## **BID ADDENDUM NO. 6**

### **Johnson Student Center**

### **Building Demolition, Increment 1 (Demolition) and Increment 2**

RANCHO SANTIAGO COMMUNITY COLLEGE DISTRICT  
SANTA ANA, CA

STRUCTURAL STEEL BEAM

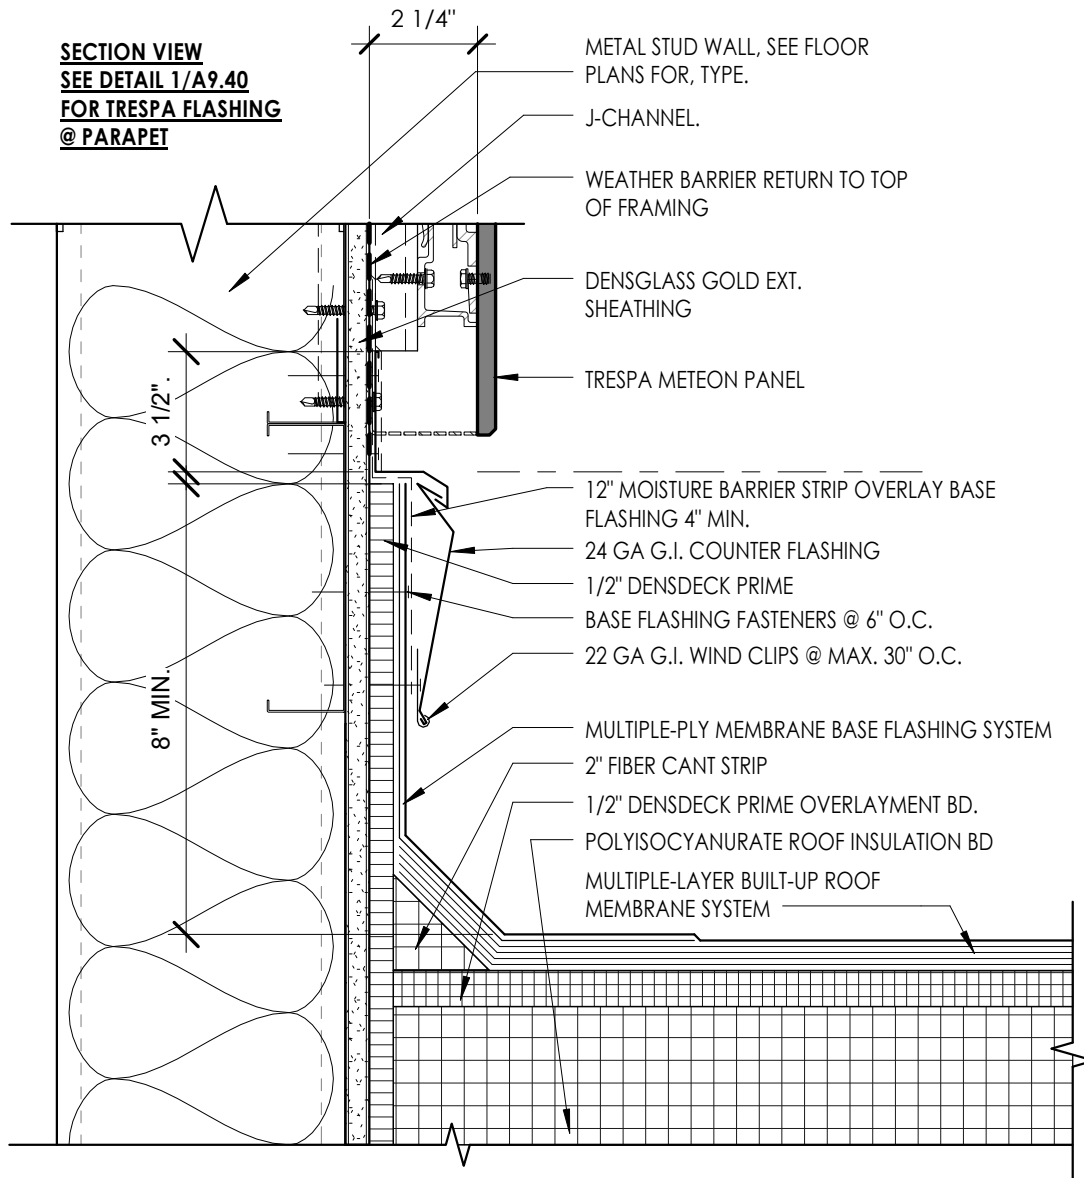
Increment # 2 – On sheet A2.30 along gridline D please clarify the parapet finish and the extent of each finish along this line. Wall cut 1/A5.03 near gridline 3.2 seems to indicate that the roofing wraps up the parapet on the west side, however detail 1/A9.31 at the access ladder seems to indicate that there is metal panel along this side of the parapet. Please clarify the west side and also confirm that the roofing on the east side of this parapet wall wraps up the roof to the parapet cap and is not something else.

Please also clarify the finish on the south side of the parapet along gridline 7. The only detail cut along this wall (27/A9.31) is for the screen wall at the AHU, which is not this wall. And the elevations for this area do not have a material call out (see attached). We are assuming the north side of this parapet wall is the roofing membrane wrapped up the wall.

- USE DETAIL 2/A9.32 FOR PARAPET BETWEEN GRIDLINE 3.2 & 3.9
- BETWEEN GRIDLINE 3.9 TO GRIDLINE 5 USE ATTACHED DETAIL RFC 66.1
- BETWEEN GRIDLINE 5 TO GRIDLINE 7, USE ATTACHED, RFC 66.2 (REVISED DETAIL 1/A9.31 - LADDER WHERE OCCUR)

- SEE ATTACHED PLAN FOR THE LOCATION OF TRESPA PANEL DIMENSIONED 19'-6"
- REFER TO DETAIL 1/A9.40 FOR TRESPA FLASHING AT PARAPET
- REFER TO ATTACHED RFC 66.3 FOR TRESPA BASE AT ROOF (PROVIDED DETAIL 1/RFC 66.3)
- @ PLASTER PARAPET USE ATTACHED, RFC 66.2 (REVISED DETAIL 1/A9.31)

Cut out from sheet A7.10

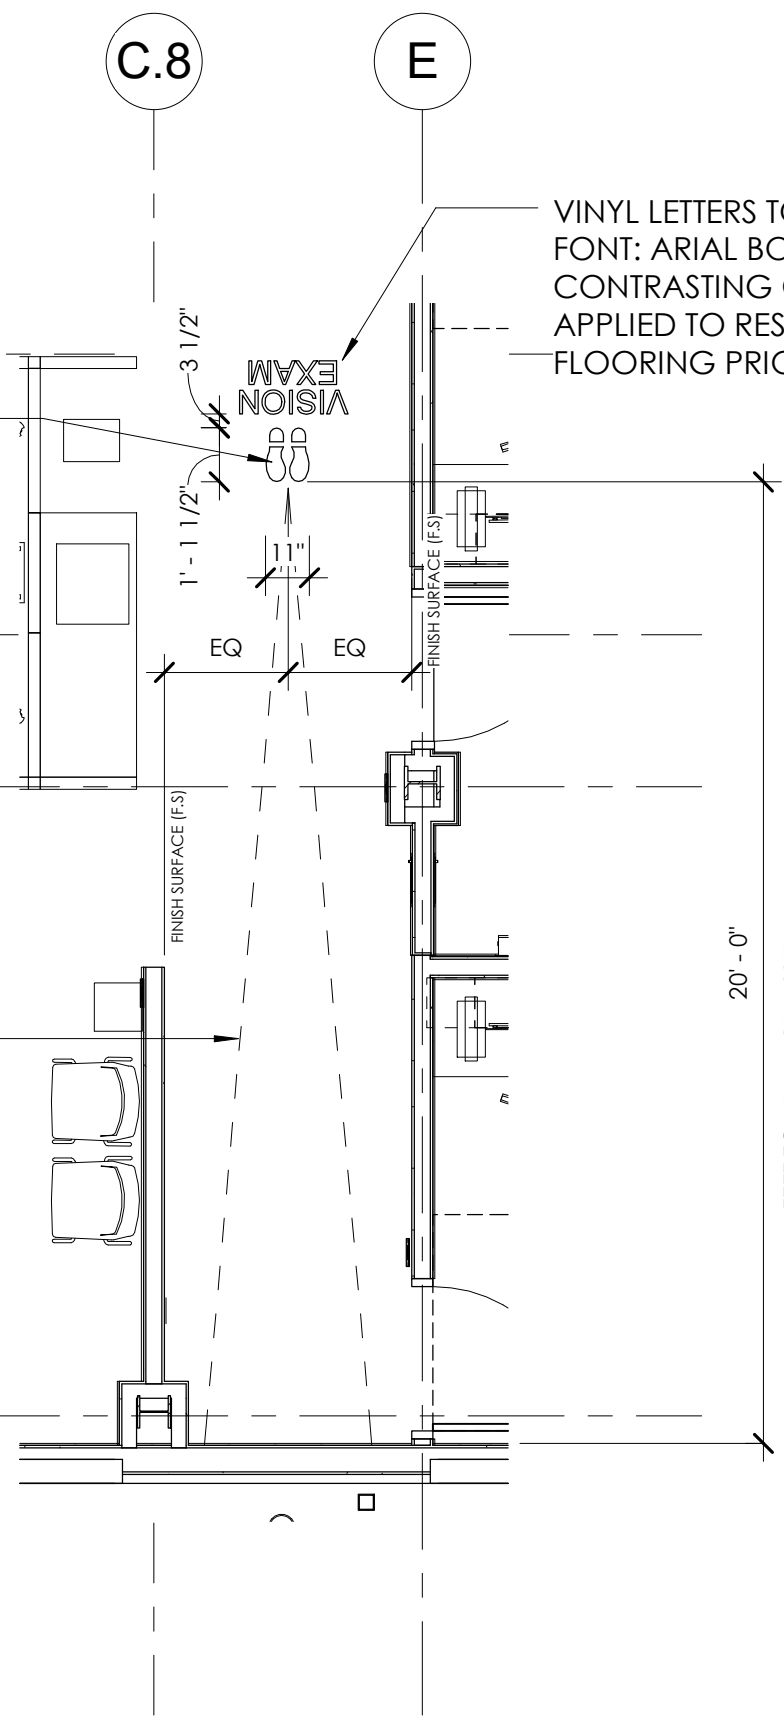
DATE:	09/26/2018		
FROM:	S.Monsen - McCarthy	EMAIL:	SMonsen@McCarthy.com
SPECIFICATION NUMBER:		DRAWING NUMBER:	A7.10
REQUESTED CLARIFICATION:			
<p>Increment #2 - Sheet A7.10 - Health &amp; Wellness Office room J110-8 on A7.10 shows "vision exam" on floor plans designating a pre-set standing location for patients. See markup attached for exact location. Please clarify if this "vision exam" with shoe location and hashed vision lines is to be a decal or a graphic set into flooring. Additionally please provide information necessary for pricing. (i.e. applied paint with sealed top coat or graphic applied resilient sheet flooring)</p>			
RESPONSE TO CLARIFICATION, <b>SUBMITTED AS PART OF AN ADDENDUM:</b>			
<p>Please see attached Vision Graphic Detail.</p>			
RESPONSE PROVIDED BY:	<b>Julia D. Jones / hpi</b>	DATE:	<b>10/15/18</b>

**ENLARGED ROOF PLAN**

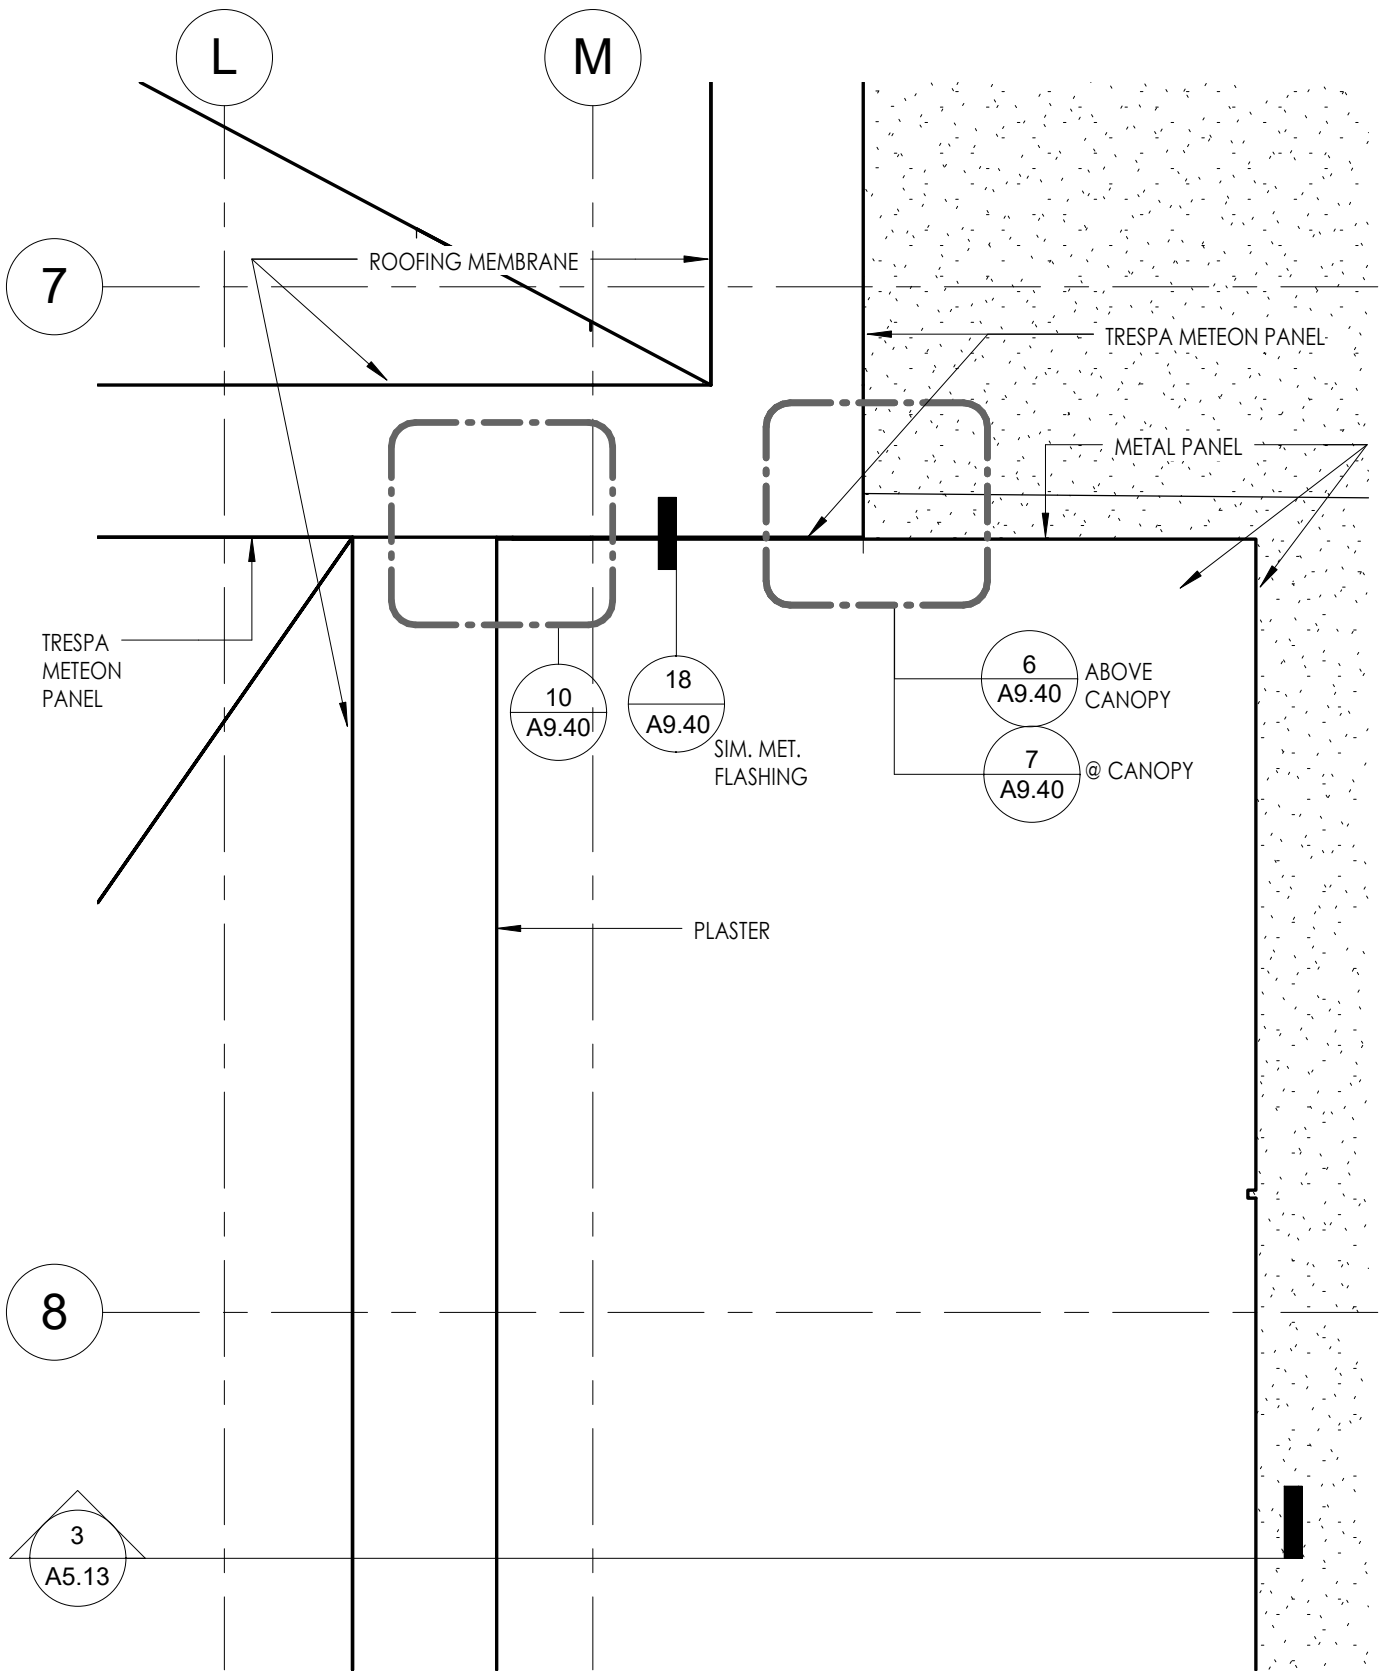
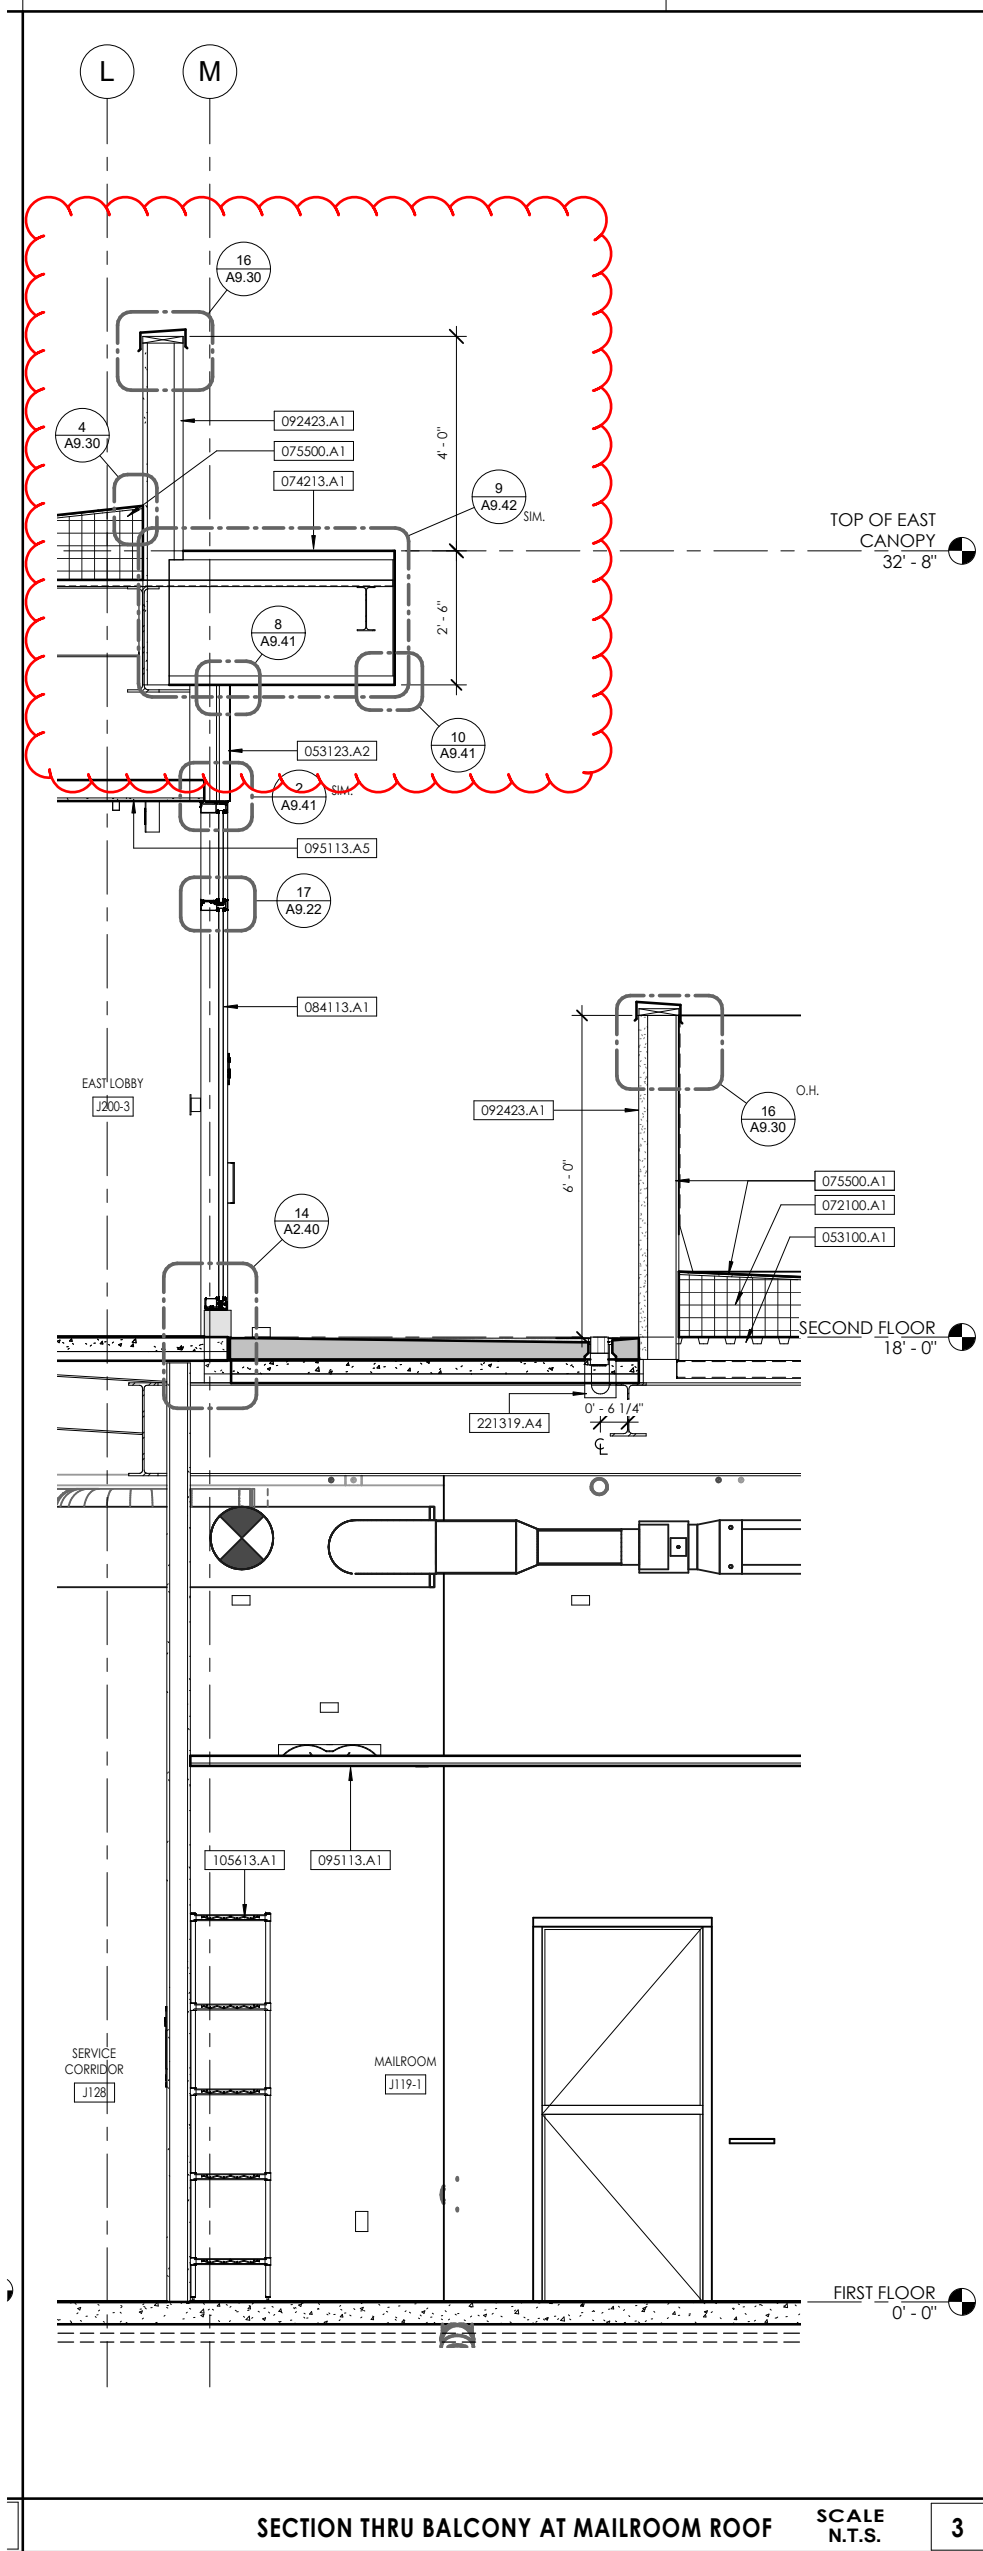
Increment # 2 – Refer to sheet A2.30 and Detail 3/A5.13 - Please clarify and provide additional details for how the plaster, metal wall panels and decorative wall panels all come together at the below location and provide a watertight assembly.

- SEE ENLARGED ROOF PLAN @ ATTACHED RFC 67 (PAGE 2)
- SEE REVISED 3/A5.13 @ ATTACHED RFC 67.1

**SSSP UPWARD BOUND-ENLARGED FLOOR PLAN - PRIVATE TUTORING ROOMS TYPICAL**

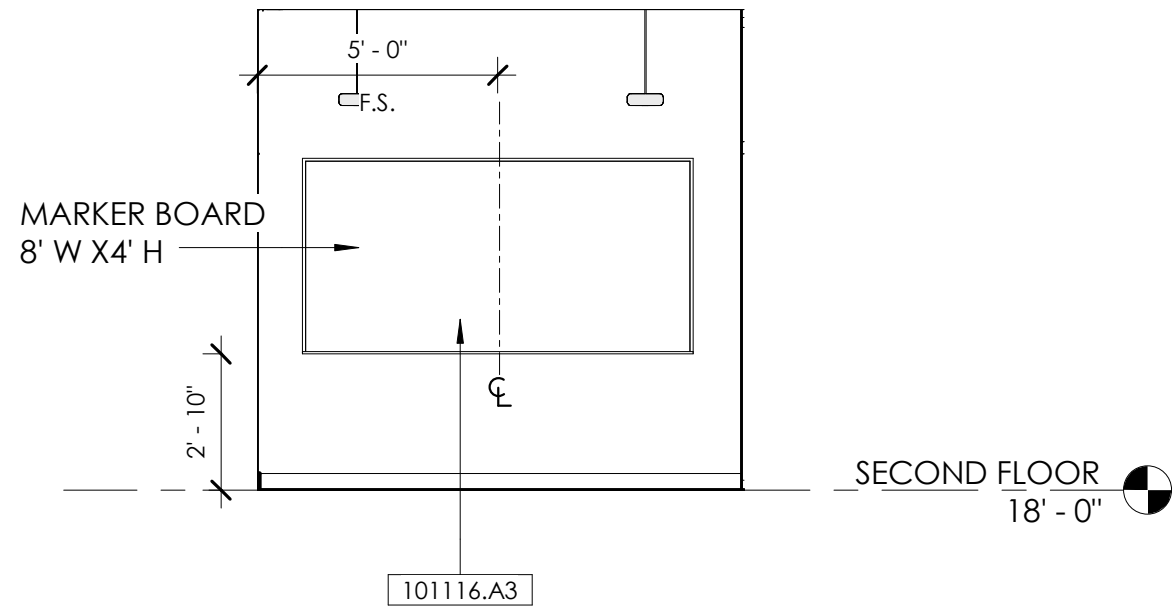
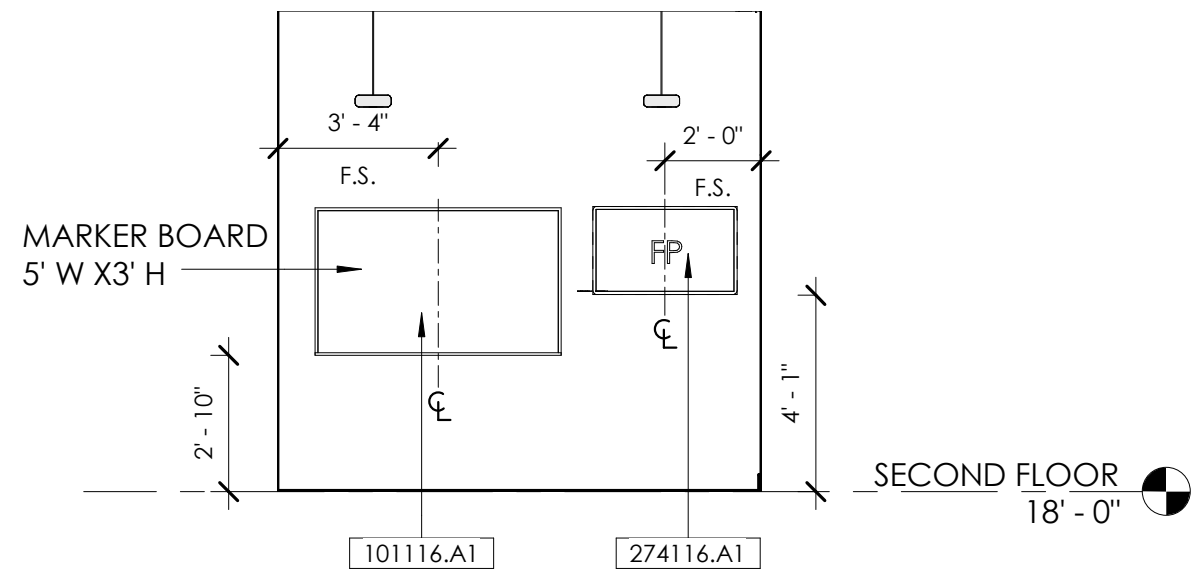
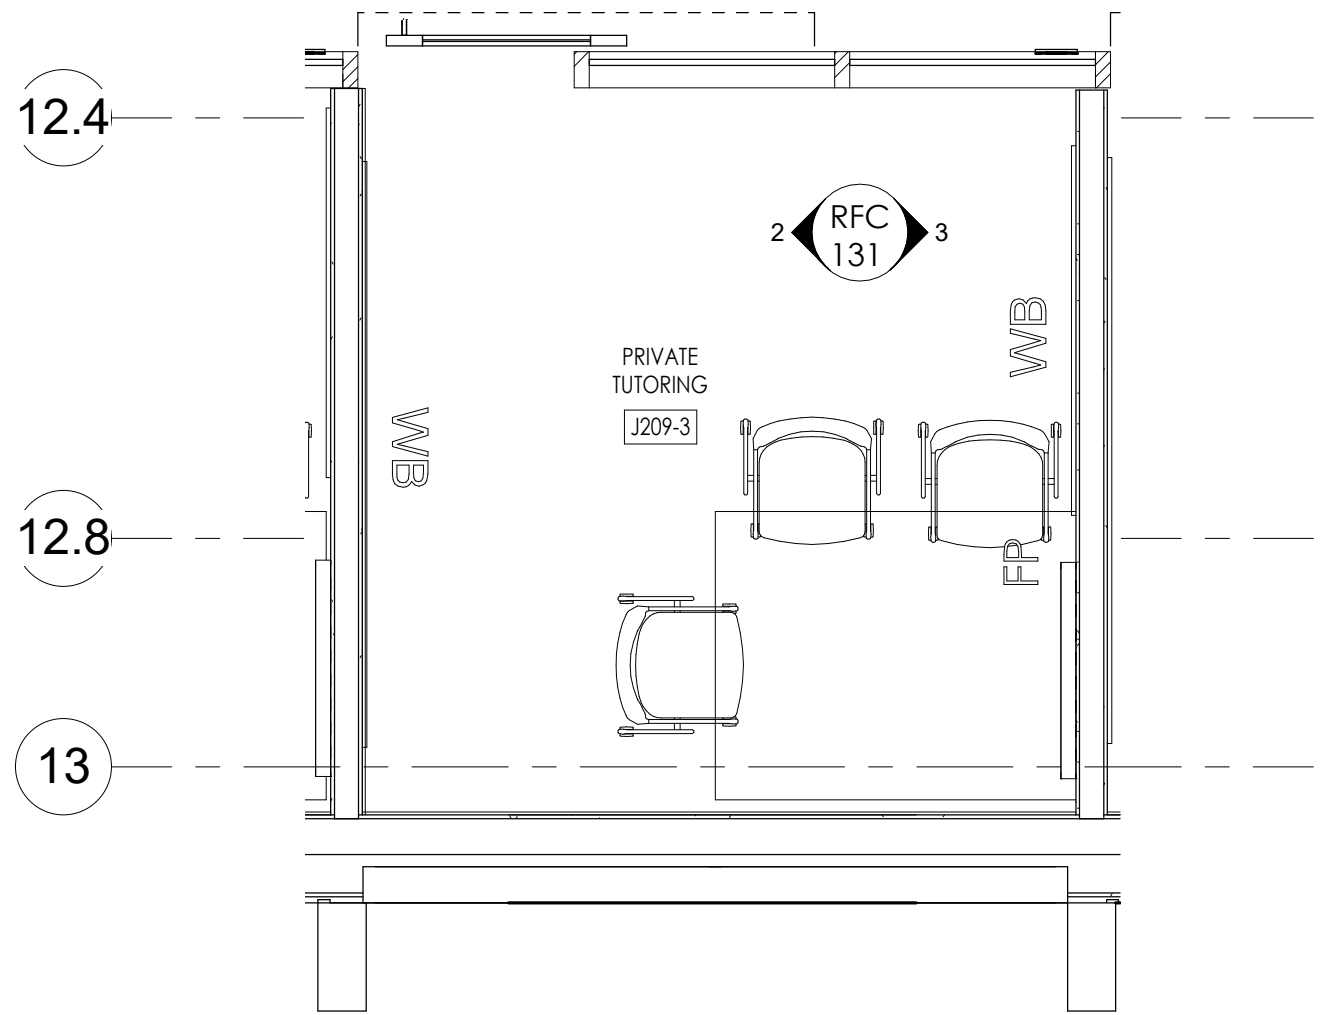
Increment #2 - Sheet A7.25, Detail 8 Private Tutoring Rooms J209-2, J209-3, J209-4 all call for a "WB" on a side wall, however those walls are not shown in an Elevation detail. Note that "WB" does not appear as a description on the "Floor Plan - Legend". However, we believe these are probably White Boards. Please confirm if these are whiteboards and if they are to be included.

If so provide the size, type & elevations since either Sections 101116 or 274116 could apply depending on which product is indicated. Note that Section 274116 Exhibit B does not list these Private Tutoring rooms, thus these are likely to be typical Section 101116 markerboards.

Please review and confirm if the bidders are to include any more Floor Plan call outs for "WB" but which are not shown on a Interior Wall Elevation.
